Front Bumper Cover Gap at Fender

YEAR(S)	MODEL(S)	ADDITIONAL INFORMATION
2014 - 2020	4Runner

Introduction

Figure 2. Retainers

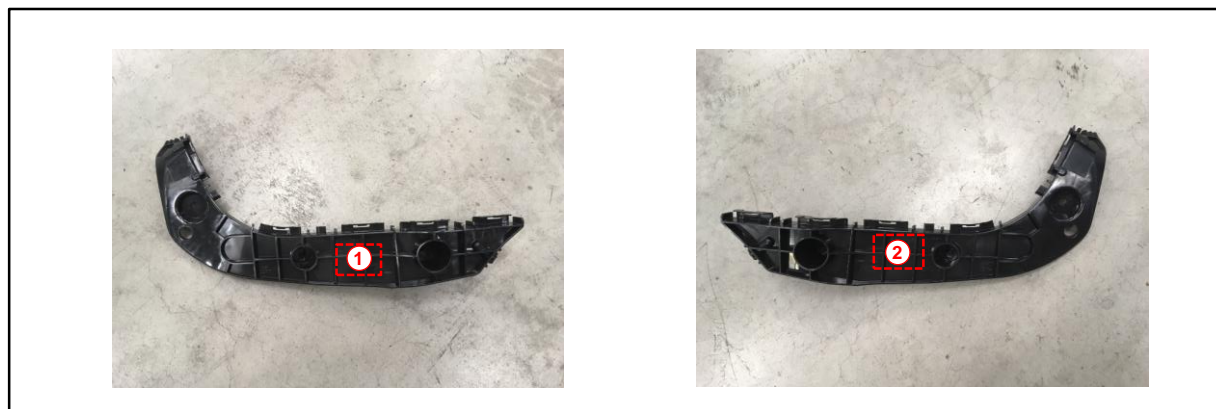
2. Remove the front bumper cover.
Refer to TIS, applicable model and model year Repair Manual:
 - [2014](#) / [2015](#) / [2016](#) / [2017](#) / [2018](#) / [2019](#) / [2020](#) 4Runner:
Vehicle Exterior – Exterior Panels/Trim – “Exterior Panels/Trim: Front Bumper: Removal”
3. Remove the old retainers and Install the NEW retainers.

1	Left-hand Side Retainer (Part No. 52116-35153)	2	Right-hand Side Retainer (Part No. 52115-35153)
---	--	---	---

Figure 3. Primer Application and Dual Lock™ Fastener Installation Areas on the Front Bumper Cover

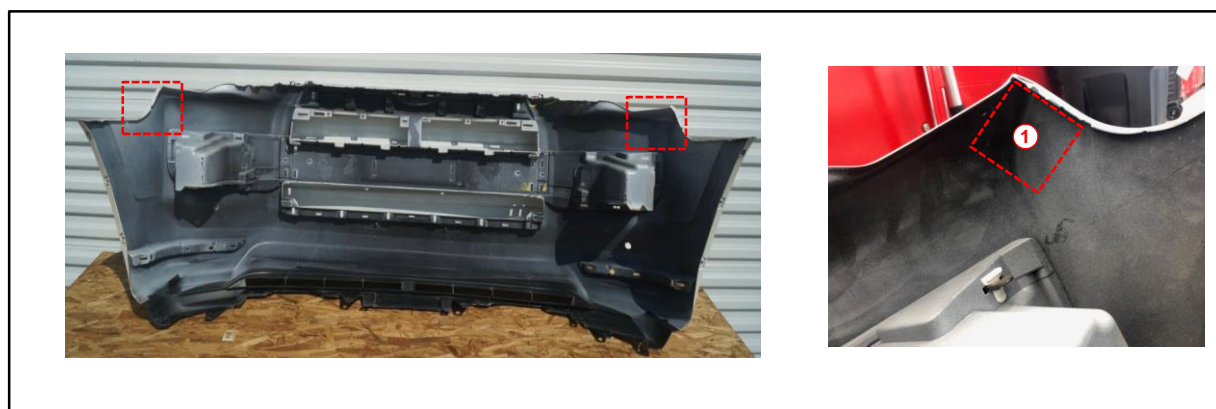
1	Along the Side Wall
---	---------------------

Figure 6.

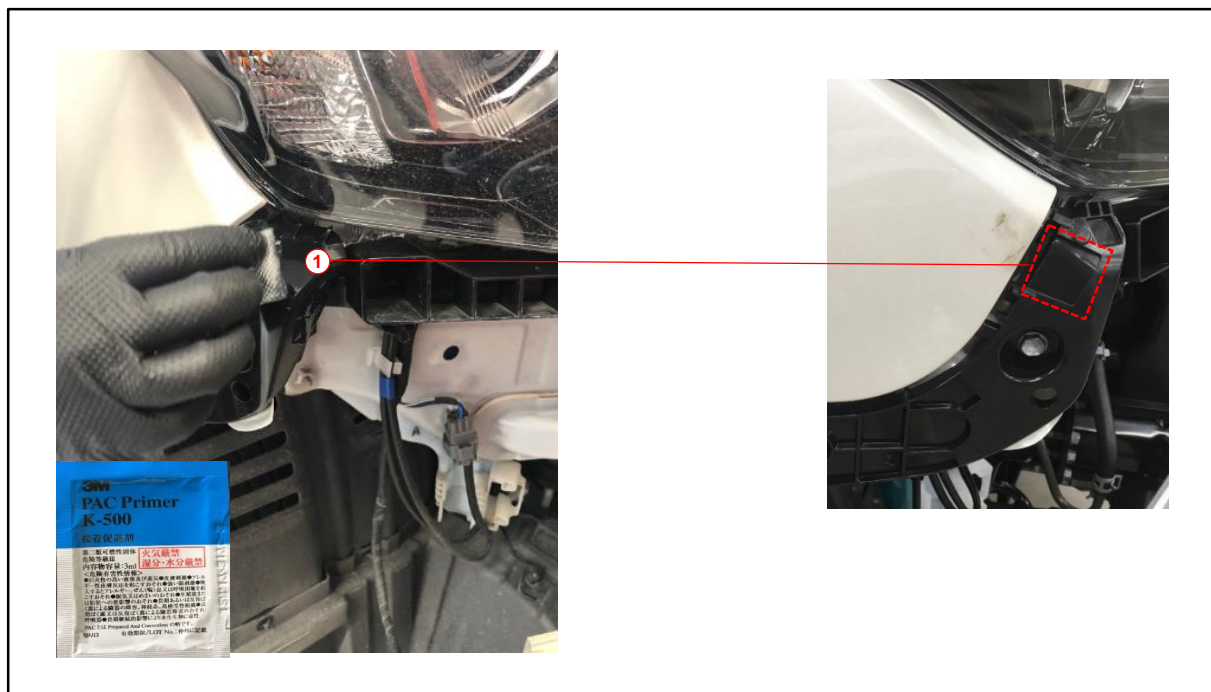
6. Apply 3M™ PAC Primer K-500 to the retainer surface on each side where the Dual Lock™ Fasteners will be installed and allow it to dry for AT LEAST two minutes.

| 1 | Apply 3M™ PAC Primer K-500 |

Figure 7.

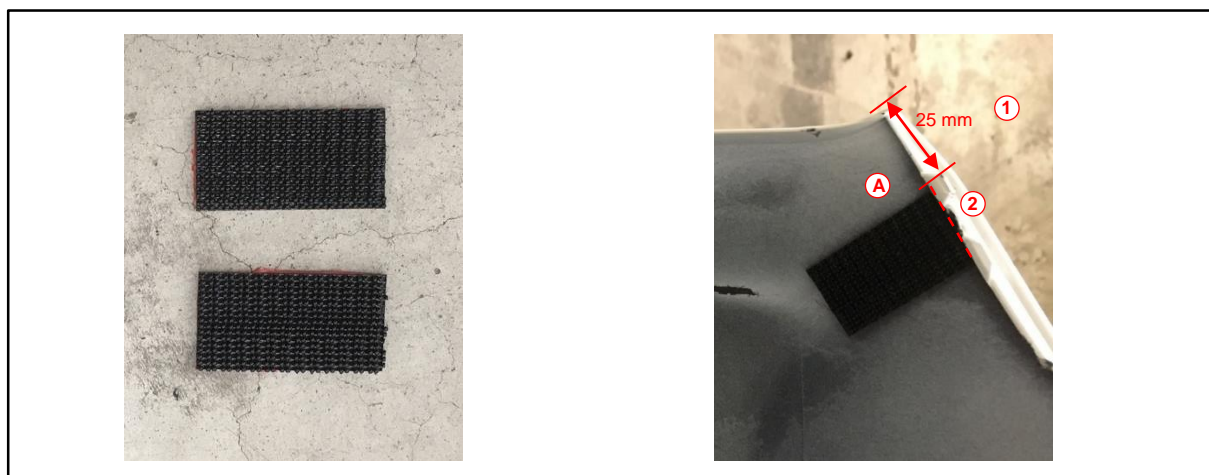
7. Apply the larger Dual Lock™ Fasteners (35 mm x 20 mm) to each side of the front bumper cover.

A	Front Bumper Cover Side Wall
1	Apply Along the Shape
2	Apply Along the Line

Figure 9.

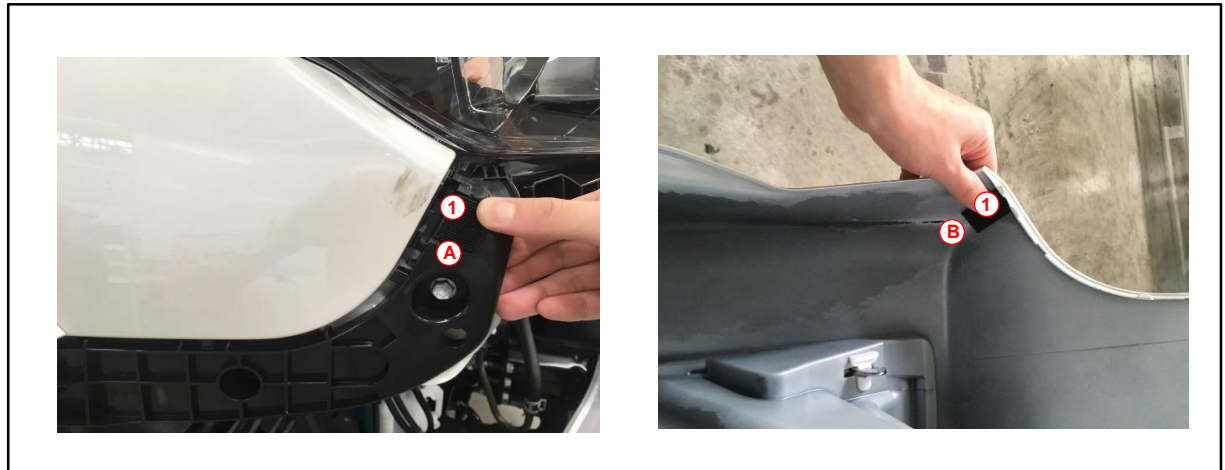
9. Confirm proper Dual Lock™ Fastener adhesion by pressing on ALL Dual Lock™ Fasteners.

A	Retainer
1	Press

B	Front Bumper Cover Side Wall
1	Press

Make sure the bottom of each Dual Lock™ Fastener is completely pasted on the front bumper cover and retainer surfaces.
